Access Compliance Report

Public Rights-of-Way

(Curb Ramps)

Intersection ID: 52288	Main Street: STEELE_CREEK_RD	Cross Street: DIXIE_RIVER_RD	Location: S
ADA ID: 540F2E246F90	Ramp Type: Perp	Initial Pass/Fail: Fail	Overall Compliance: No
Severity Score: 22.5			
Codes/Mitigation Info/Possible Solution		Field Measurements/Component Compliance

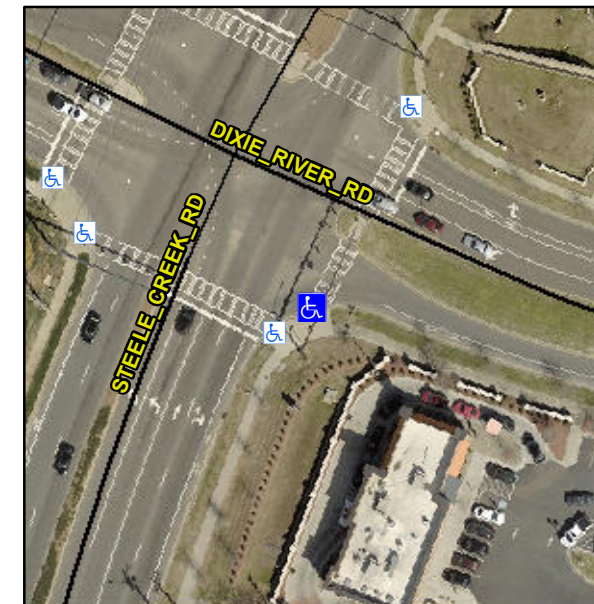
R304.5.1, R304.2.2, R304.5.3

Compliance	Description	Data	Compliance	Description	Data
N/A	Ramp Length (in)	96.0	No	Ramp Slope (%)	8.4
No	Ramp Width (in)	47.0	No	Ramp XSlope (%)	3.6
N/A	Flare Type LT	N/A	N/A	Flare Type RT	N/A
N/A	Flare Slope LT (%)	N/A	N/A	Flare Slope RT (%)	N/A
N/A	Flare Traversable LT?	N/A	N/A	Flare Traversable RT?	N/A
N/A	Landing Length (in)	N/A	N/A	DWS Provided?	N/A
N/A	Landing Width (in)	N/A	N/A	DWS Contrast?	N/A
N/A	Landing Slope (%)	N/A	N/A	DWS Length (in)	N/A
N/A	Landing X Slope (%)	N/A	N/A	DWS Full Width?	N/A
N/A	Landing Curb? (Y/N)	N/A	N/A	DWS Offset (in)	N/A
N/A	Shared Landing?	N/A			
N/A	Gutter Ponding?	N/A	N/A	Gutter Slope (%)	N/A
N/A	Gutter Lip Ht (in)	N/A	N/A	Gutter X Slope (%)	N/A
N/A	Painted X Walk1?	Yes	N/A	Painted X Walk2?	N/A
	X Walk 1 Direction	To NE		X Walk 2 Direction	N/A
N/A	X Walk 1 Width (in)	112.0	N/A	X Walk 2 Width (in)	N/A
	X Walk 1 Slope (%)	1.8		X Walk 2 Slope (%)	N/A
	X Walk 1 X Slope (%)	0.1		X Walk 2 X Slope (%)	N/A

Remove & Replace Entire Ramp.
